FILE NAME: 1.010.050.1 - Engine Wiring 2.4 JTD 20V - Rev8		NOTE: BOOST PRESSURE SENSOR 3 PIN	
	PROJECT: HPE225/HPE250 - 2.4 JTD 20V		CMD CODE: 1.010.050.1	SCALE: not
DESIGNED: G. CUOMO	SPECIFICATIONS: Unless otherwise specified the dimensions are in mm. Tolerances: +10mm-0mm		SIZE: A3	
CHECKED: G. CUOMO	WIRING PINOUT			
DRAWN: S. LA MANNA	PROPRIETARY NOTICE:

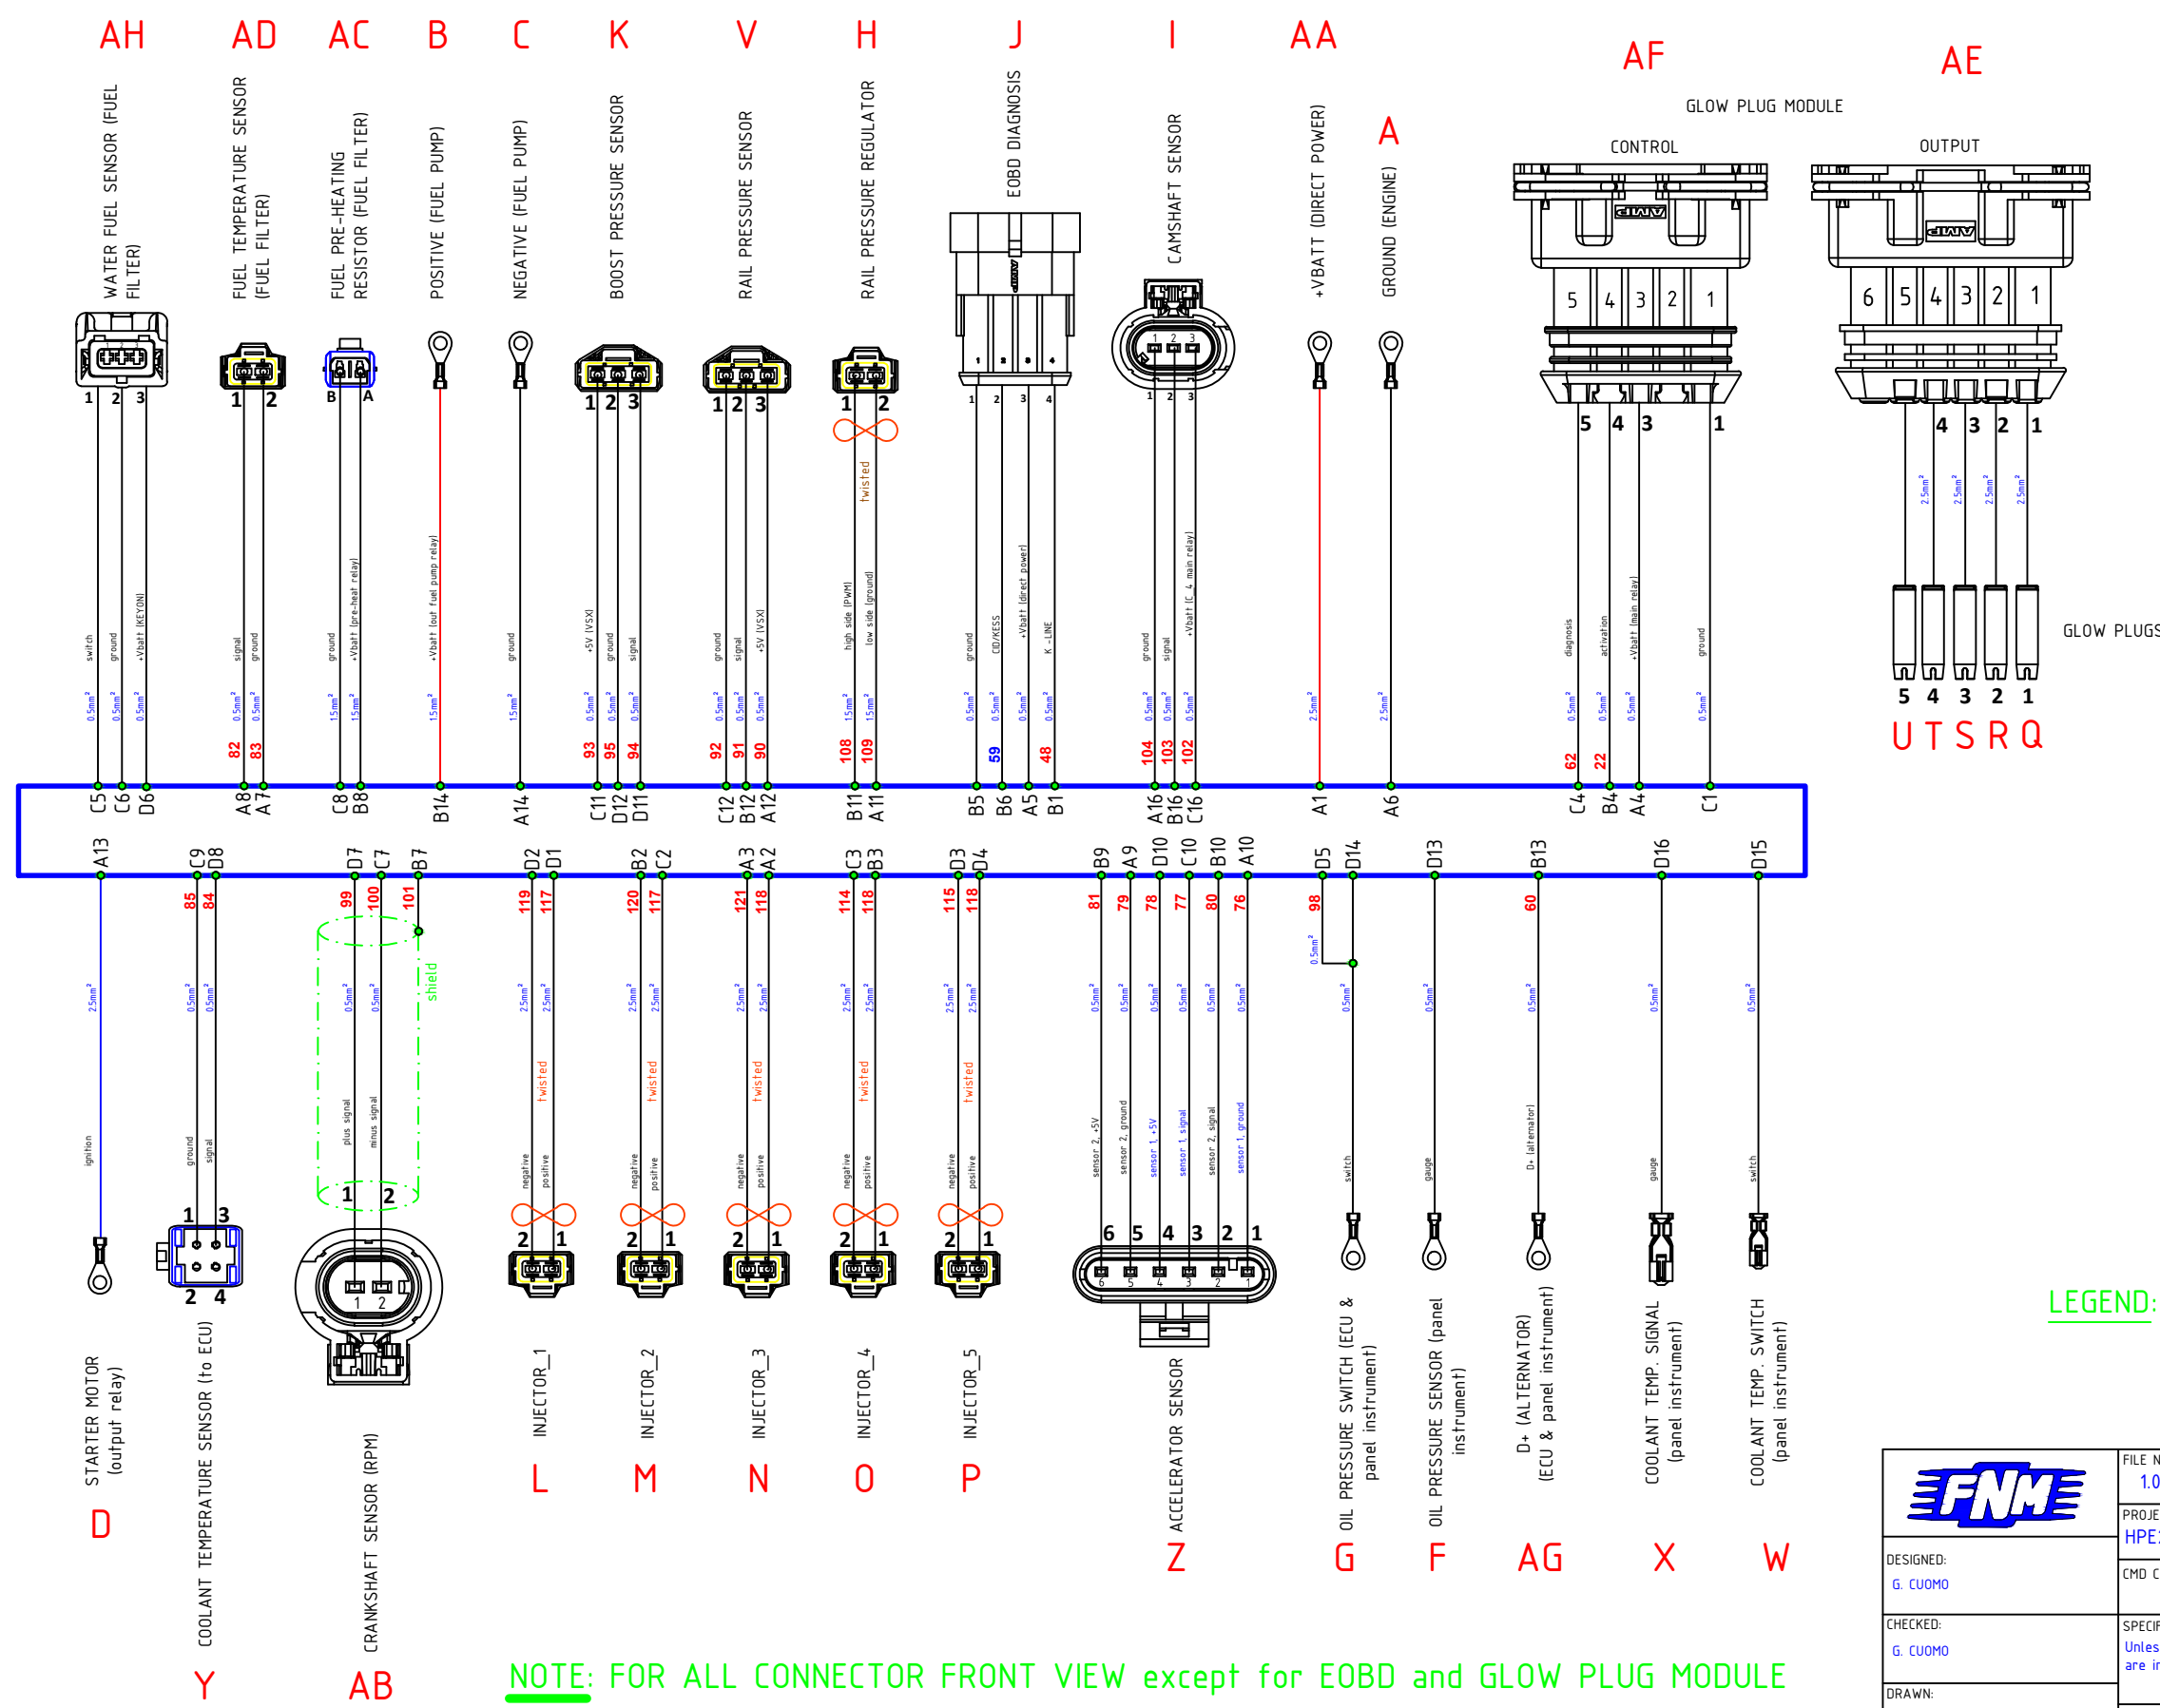
MODIFICHE (REVISIONS)			
ZONE	REV	DESCRIPTION	DATE
	7	From year 2010 to July 2016	10/03/2011
sheet 1 of 3: C4-C5-D5	8	Changed lengths: T2-T20 from 550mm to 300mm, T20-H from 100mm to 350mm, T20-I from 210mm to 460mm.	12/07/2016
